Permit Application Review Report
Date: 8/20/2025

Project Name: Dercon

Project PAN: P-25-022

Project Purpose: Construction of a new commercial building and associated stormwater treatment features

Figure 2: Site Plan\

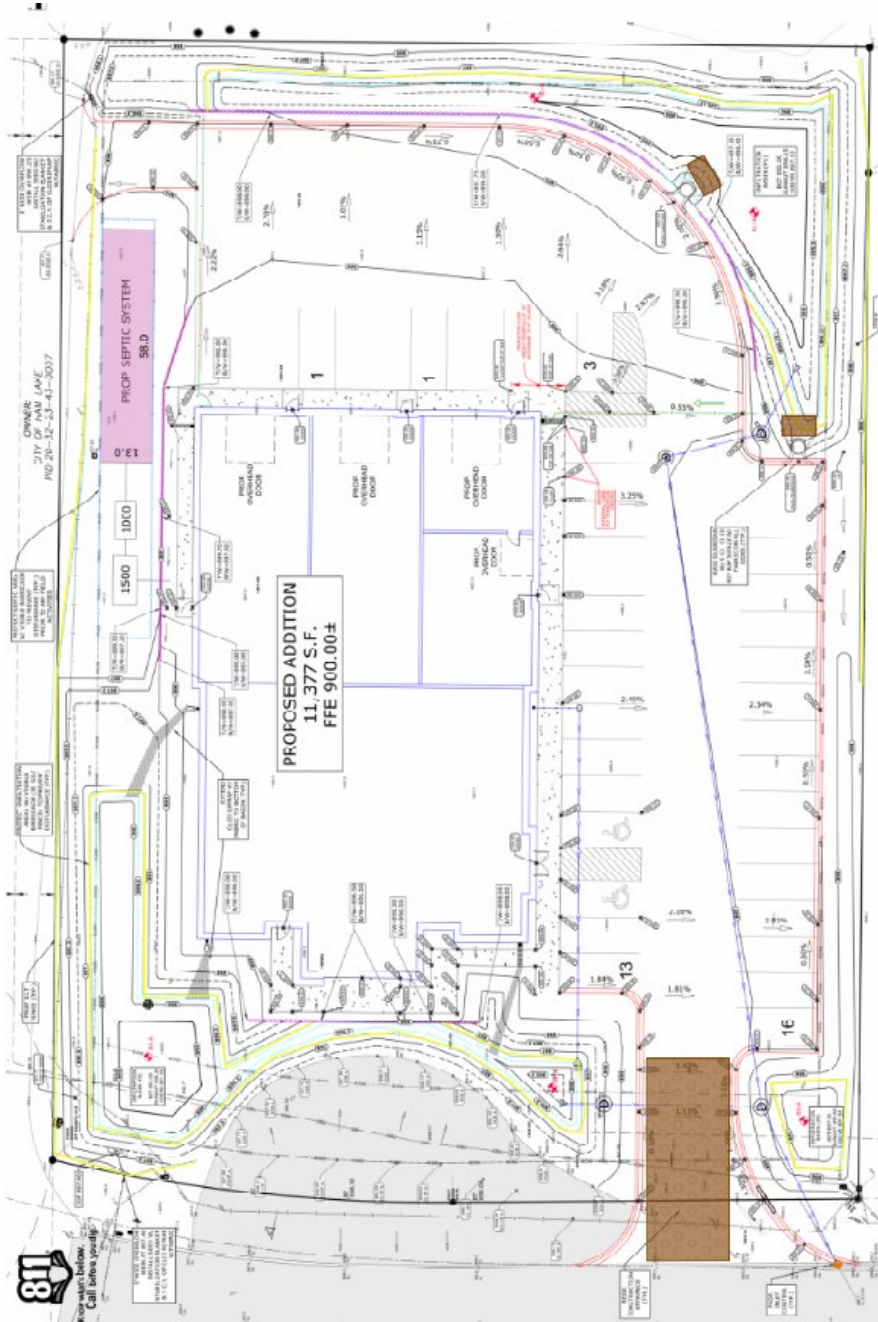
Description: The applicant is proposing the construction of a new commercial building, parking and stormwater treatment features. It will disturb 1.31 acres and create 0.82 acres of regulated impervious. The parcel drains toward County Ditch 59. The relevant water resource concerns are stormwater management and soils and erosion control which correspond to District Rules 3 and 4. See attached Figure 1: Project Location and Figure 2: Site Plan.

Rate Control: Peak stormwater flow rate at each point of site discharge does not increase from the pre-development condition for the 24-hour precipitation event with a return frequency of 2-, 10-, 100- years as shown in Table 1. The project will not impact Drainage Sensitive Use areas. The rate control standard is met.

Volume Control: The proposed project is new development; therefore, the volume reduction requirement is equal to 1.1 inches over the area of all impervious surface. The amount of proposed impervious required to be treated is 35,704 ft².

Drainage Area A4 is a small portion of the driveway entrance that is unable to be routed to a treatment feature. The volume control standard has been met to the maximum extent practicable as shown in Table 2.

Low Floor Freeboard: The proposed project is new development which includes buildings and habitable structures. Therefore, SMPs must be designed such that the lowest basement floor elevations are at least 2 feet above the 100-yr high water level or 1 foot above the emergency overflow. The lowest basement floor elevation proposed is 900 ft NAVD 88. The applicable 100-year high water levels are 898 and 897.5 ft NAVD 88 and the applicable emergency overflows are 898 and 897.5 ft NAVD 88. The freeboard requirement is met.
